Access Compliance Report

Public Rights-of-Way

Intersection ID: 12267	Main Street: CENTRAL_AV	Cross Street: LOUISE_AV	Location:	N
ADA ID: 8A4A531BA50A	Ramp Type: BlendTrans1	Initial Pass/Fail: Fail	Overall Compliance: No	Severity Score: 8.75

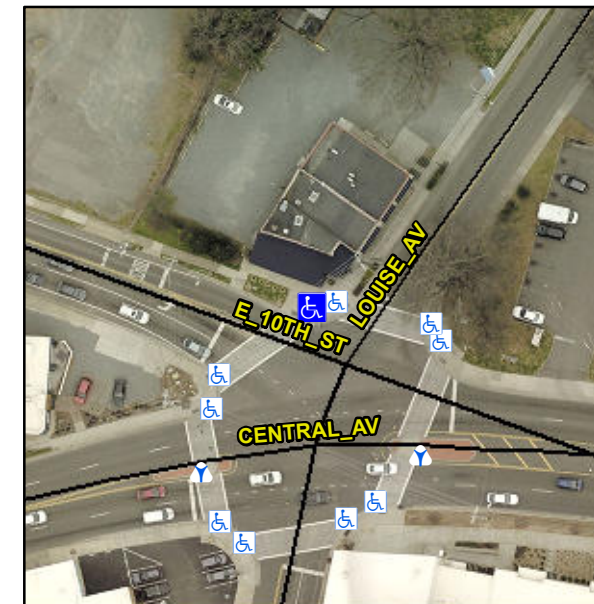
Remove & Replace Curb Ramp With Two New Directional Ramps or Equivalent.

Not Found, R304.5.1
